Project	<b>IEEE 802.16 Broadband Wireless Access Working Group</b> < <a href="http://ieee802.org/16">http://ieee802.org/16</a> >	
Title	<b>Performance enhancement with efficient mapping of outer-coded MBS streams</b>	
Date Submitted	<b>2008-09-11</b>	
Source(s)	Erik Colban, Yoav Nebat, Lei Wang, Kenneth Stanwood, Yair Bourlas NextWave Wireless*	Voice: E-mail: <a href="mailto:ecolban@nextwave.com">ecolban@nextwave.com</a> ; <a href="mailto:lwang@nextwave.com">lwang@nextwave.com</a> ; <a href="mailto:kstanwood@nextwave.com">kstanwood@nextwave.com</a> <a href="mailto:ybourlas@nextwave.com">ybourlas@nextwave.com</a>
		*< <a href="http://standards.ieee.org/faqs/affiliationFAQ.htm">http://standards.ieee.org/faqs/affiliationFAQ.htm</a> > >
Re:	802.16 Rev2 Sponsor Ballot	
Abstract	This contribution proposes a few changes into the 802.16 Rev2/D6 that will provide the required supports to improve the system performance of MBS services for the 802.16e OFDMA PHY based systems.

# Performance enhancement with efficient mapping of outer-coded MBS streams

**Figure YY1 – Location of OFDMA symbols in the OCTINS domain**

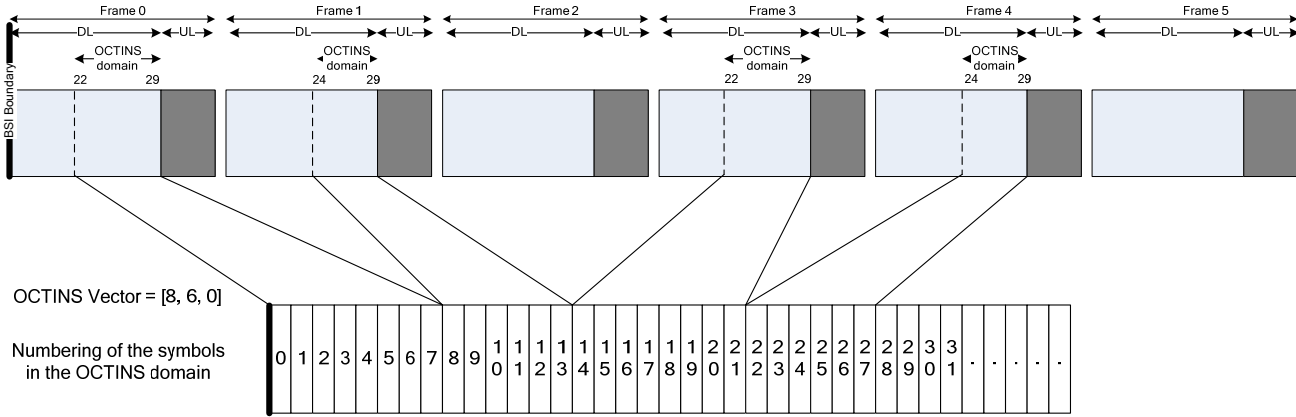
The OCTI\_MAP message specifies the allocations for each stream using the OCTI Numbering System (OCTINS). The OCTINS is used to index a subset of all symbols in all DL sub-frames that are transmitted during one OCTI. This subset of symbols is referred to as the *OCTINS domain*, see Figure YY1. The BS shall schedule all the streams that belong to the MBS zone within the subset of symbols that constitute the OCTINS domain.

The OCTINS domain is specified by the OCTINS vector, whose length  $N$  is less than or equal to the number of frames of the OCTI and each element is a non-negative integer less than or equal to the total number of symbols of the DL sub-frame. The OCTINS vector signals the number of symbols in each frame that are contained in the OCTINS domain. If  $V$  is the OCTINS vector,  $B$  the number of frames in the OCTI, and  $k$  is the number of a frame within the OCTI, i.e.,  $0 \leq k < B$ , then the OCTINS domain contains the  $V(k \bmod N)$  last symbols of the  $k^{\text{th}}$  DL sub-frame. The symbols in the OCTINS domain are numbered in increasing order starting with 0. The BS signals the OCTINS vector in the OCTI\_MAP message, which enables the SS to determine which frame  $k$  and which symbol  $s$  in frame  $k$  a given number  $m$  references and, thereby, interpret the mapping information in that message.

**Figure YY2 – Example of an OC-segment divided into two allocations**

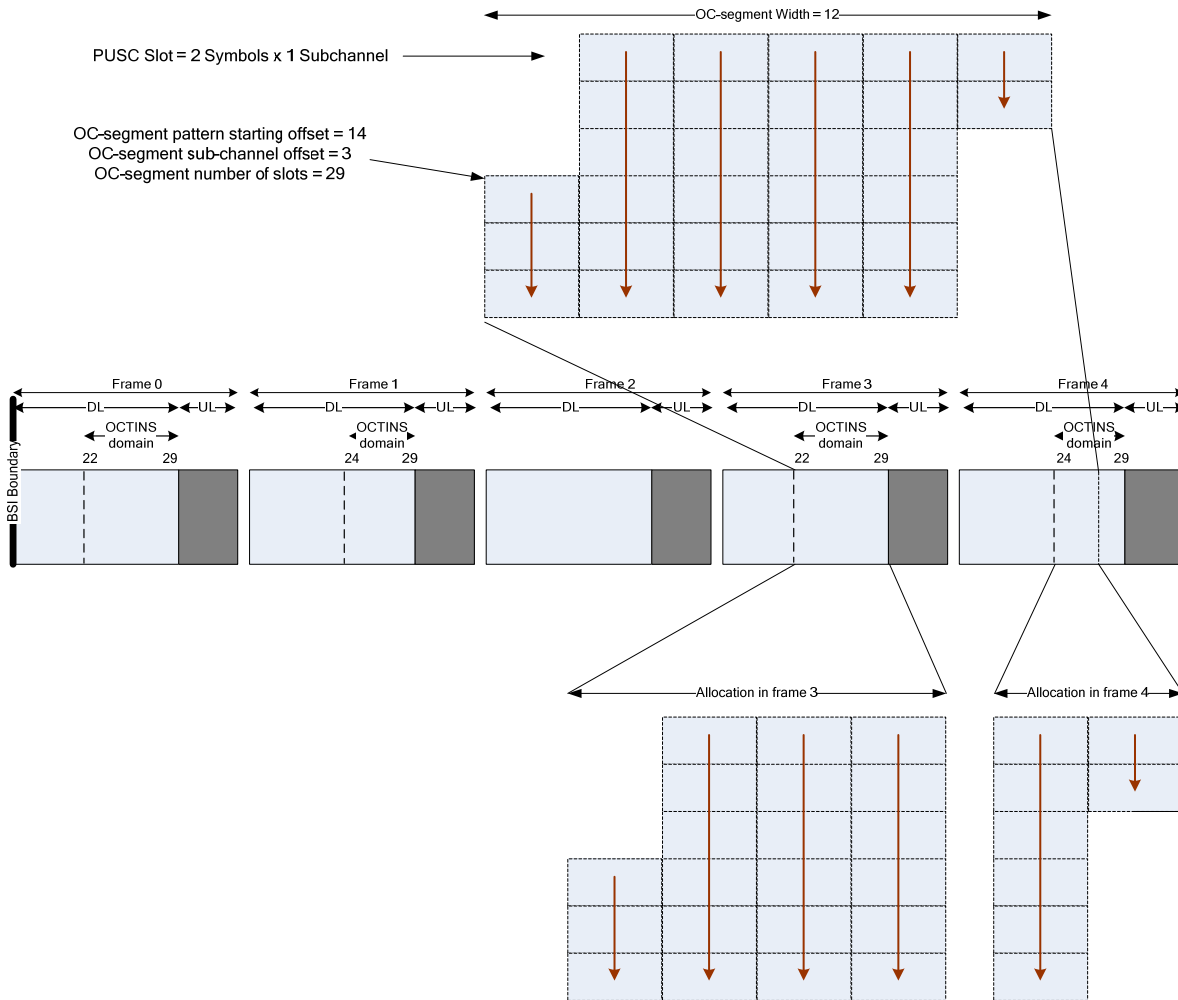
pattern of OC-segments with the same first slot offset and number of slots, which may occur a number of times with a fixed period in the OCTINS domain. Although each OC-segment is a consecutive set of slots in the OCTINS domain, an OC-segment may “straddle” multiple OFDMA frames and, therefore, may correspond to multiple allocations across multiple OFDMA frames (see Figure YY2).

Each OC-segment belonging to a sub-stream maps to one or more allocations, where each allocation is in a separate OFDMA frame. From the information in the OCTI\_MAP, the SS can determine the number of slots of each allocation, and from the DIUC it can determine the number of bytes that fit in each allocation.

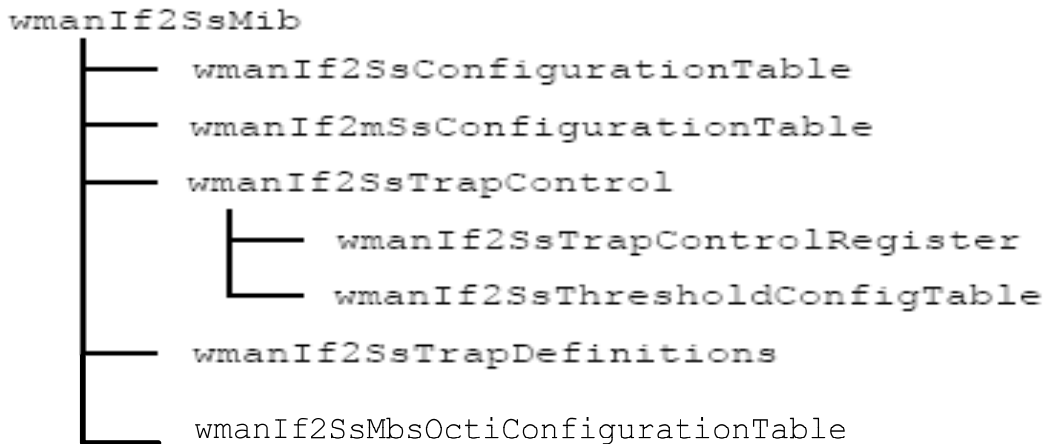
*[On page 1394, line 3, Figure 338, modify figure to include a new node named wmanIf2SsMbsOctiConfigurationTable as follows:]*
